SUBJECT: FCC Class II Permissive change for FCC ID: **2A5YZ-P20PRO**

We, the undersigned, would like to request a Class II Permissive Change for the FCC ID: **2A5YZ-P20PRO**, which was originally granted on 06/14/2024.

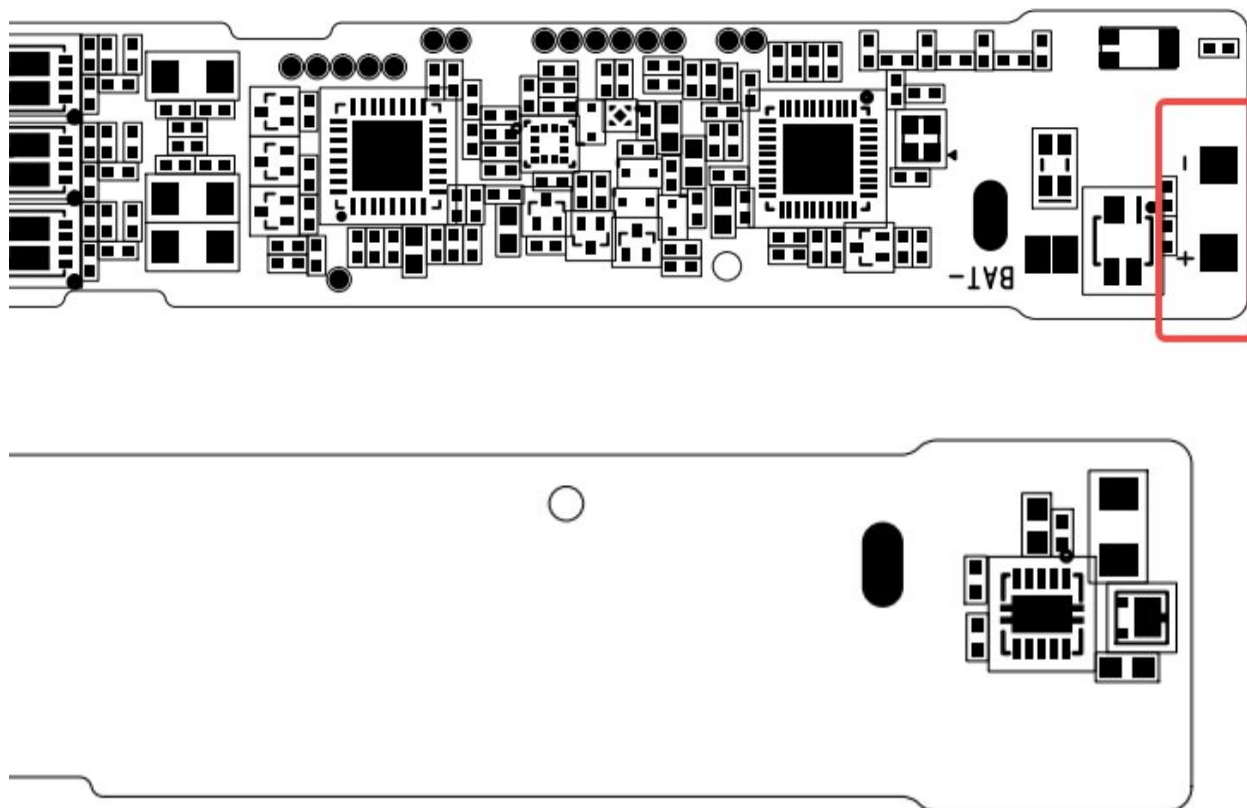
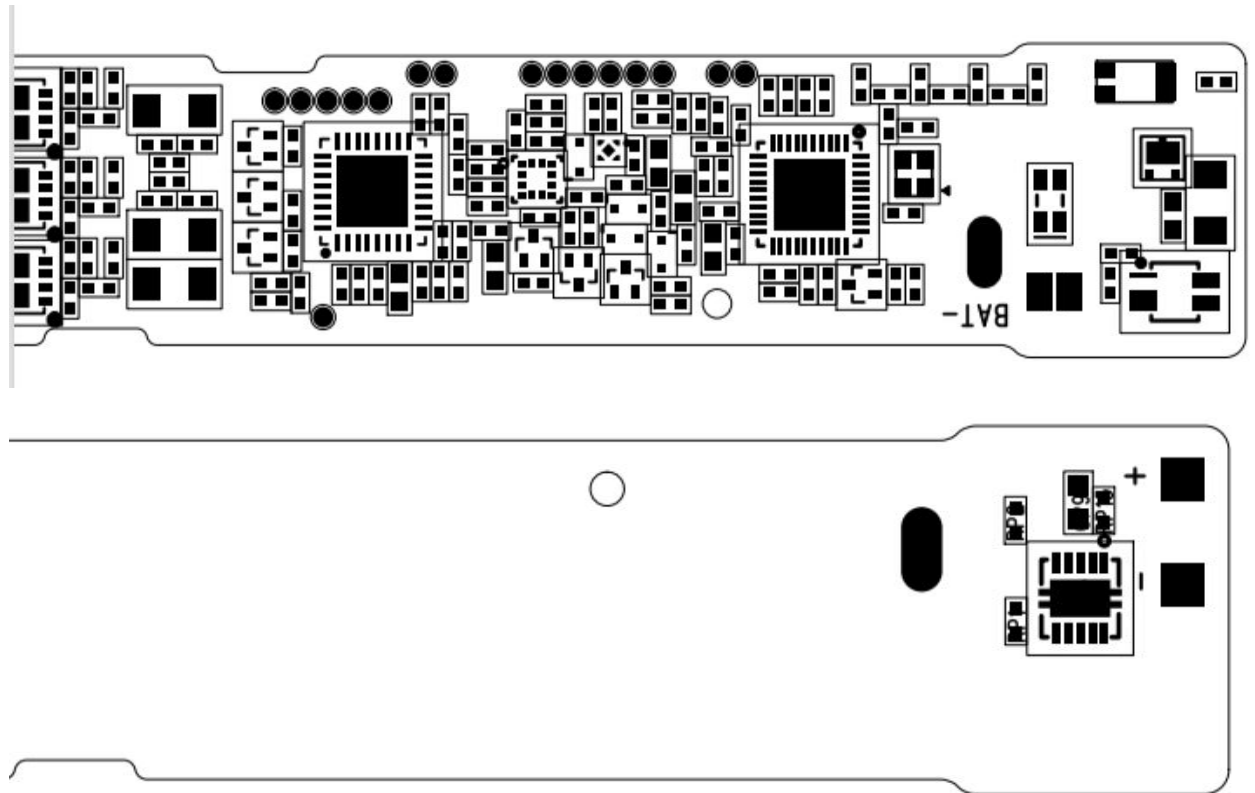
Updated the position of TYPE-C on the PCB, the fuse and VS layout on the back of the PCB, the horizontal layout of the lithium protection chip, and the internal wiring to modify the power supply part.
